**NOTICE
OSHTEMO CHARTER TOWNSHIP
PLANNING COMMISSION**

**THURSDAY, JUNE 24, 2021
6:00 P.M.**

- f) **Public Hearing: Special Use, 6480 Technology Avenue**
Corrion 9th LLC is requesting Special Use and Site Plan approval to create two additional tenant spaces within a multi-tenant building located at 6480 Technology Avenue. One of the proposed tenant spaces is for a martial arts studio.

- g) **Public Hearing: Special Use, Speedway**
Speedway LLC is requesting Special Use and Site Plan approval to demolish the existing gas station, dry cleaning, and car wash located at 1250 and 1300 S Drake Road to construct a new 4,608 sqft convenience store with a ten dispenser auto fueling canopy.

Access and Circulation

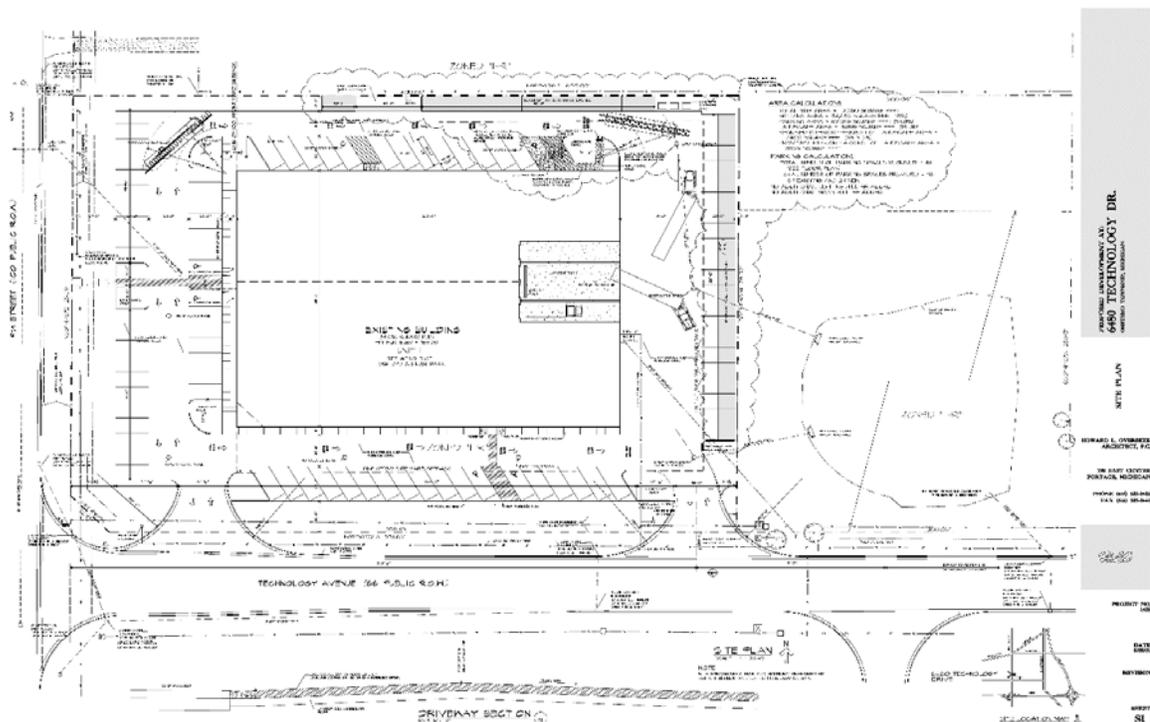
Access: The site under consideration already has two established access drives adjacent to Technology Avenue. The site is designed to accommodate two-way travel on the west and east sides while allowing only one-way travel on the north and south circulation aisles. Aisles on the proposed site plan vary anywhere between 16 Ft and 49 Ft wide. The eastern circulation aisle is

proposed to be reduced from 59 Ft in width to 49 Ft in width in order to accommodate parking needs. All other circulation aisles will remain their existing widths. The Fire Marshal has reviewed the site plan and found it adequate to service emergency vehicle circulation.

Attachments: Approved Emberly Acres II Condominium Expansion Site Plan Excerpt

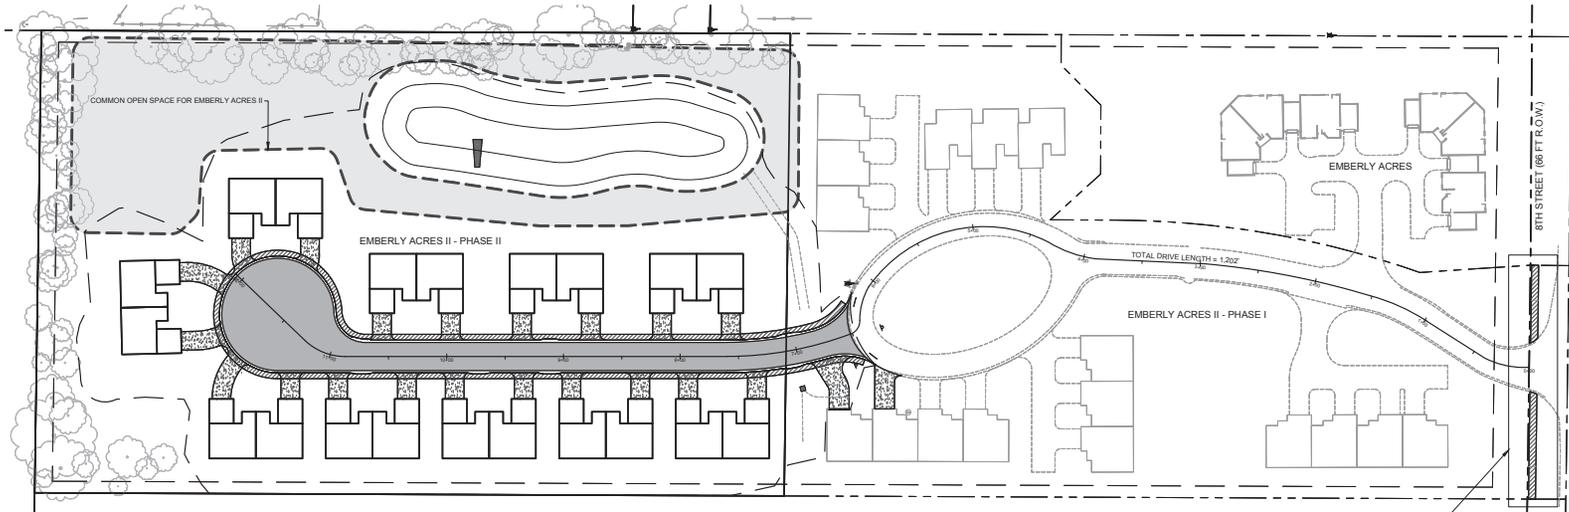
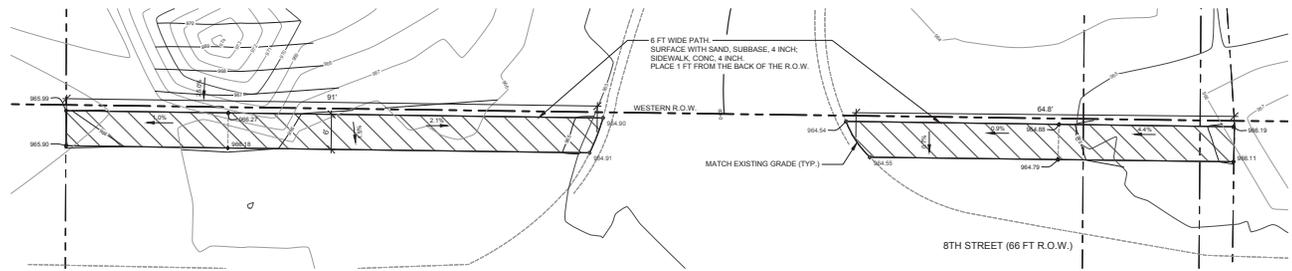
Per Section 57.90 of the Zoning Ordinance, non-motorized facilities indicated on the Township's Non-motorized Plan shall be installed by the developer when properties adjacent to planned nonmotorized facilities receive site plan approval from the municipality unless the reviewing body grants a deviation. The Township's adopted Non-motorized Plan shows a 6-foot-wide path along Emberly Acres II section of S 8th Street. The segment of the shared use path along the frontage of Emberly Acres II, Parcel ID: 05-34-230-070, was included as part of the site plan set reviewed and approved by the Planning Commission at their regular April 29th meeting.
